Access Compliance Report

Public Rights-of-Way

(Curb Ramps)

Intersection ID: 7375	Main Street: N_TRYON_ST	Cross Street: TOM_HUNTER_RD	Location: NW
ADA ID: BB54034FE7CF	Ramp Type: BlendTrans1	Initial Pass/Fail: Pass	Overall Compliance: No
		Severity Score: 0.25

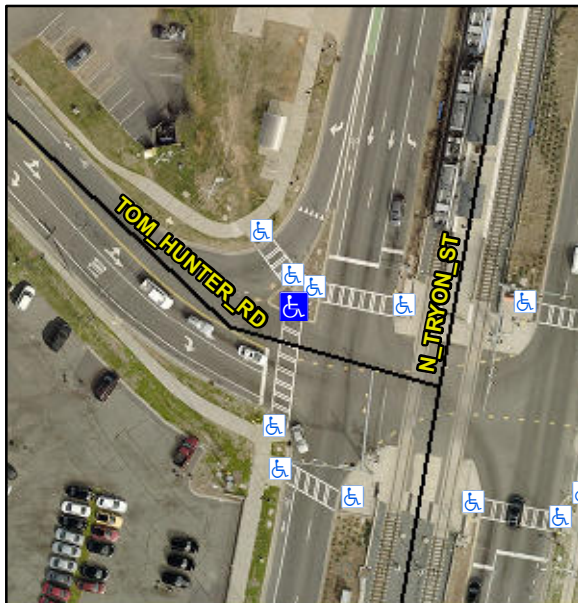
LOCATED ON MEDIAN

R304.5.3

Compliance	Description	Data	Compliance	Description	Data
N/A	Ramp Length (in)	107.0	Yes	BlendTrans Slope (%)	1.4
Yes	Ramp Width (in)	90.0	No	BlendTrans XSlope (%)	4.0
Yes	Flare Type L	Curbed_NoWalkSurface	Yes	Flare Type R	Curbed_NoWalkSurface
N/A	Flare Slope LT (%)	N/A	N/A	Flare Slope RT (%)	N/A
N/A	Flare Traversable LT?	No	N/A	Flare Traversable RT?	No
Yes	Landing Length (in)	102.0	Yes	DWS Provided?	Yes
Yes	Landing Width (in)	90.0	Yes	DWS Contrast?	Yes
Yes	Landing Slope (%)	0.2	Yes	DWS Length (in)	24.0
No	Landing X Slope (%)	4.7	Yes	DWS Full Width?	Yes
N/A	Landing Curb? (Y/N)	Yes	Yes	DWS Offset (in)	1.0
N/A	Shared Landing?	Yes			
Yes	Gutter Ponding?	No	Yes	Gutter Slope (%)	4.1
Yes	Gutter Lip Ht (in)	0.0	No	Gutter X Slope (%)	3.8
N/A	Painted X Walk1?	Yes	N/A	Painted X Walk2?	N/A
	X Walk 1 Direction	To S		X Walk 2 Direction	N/A
	X Walk 1 Width (in)	107.0		X Walk 2 Width (in)	N/A
	X Walk 1 Slope (%)	1.4		X Walk 2 Slope (%)	N/A

Remove & Replace Curb Ramp With Two New Directional Ramps or Equivalent. Remove & Replace Gutter.
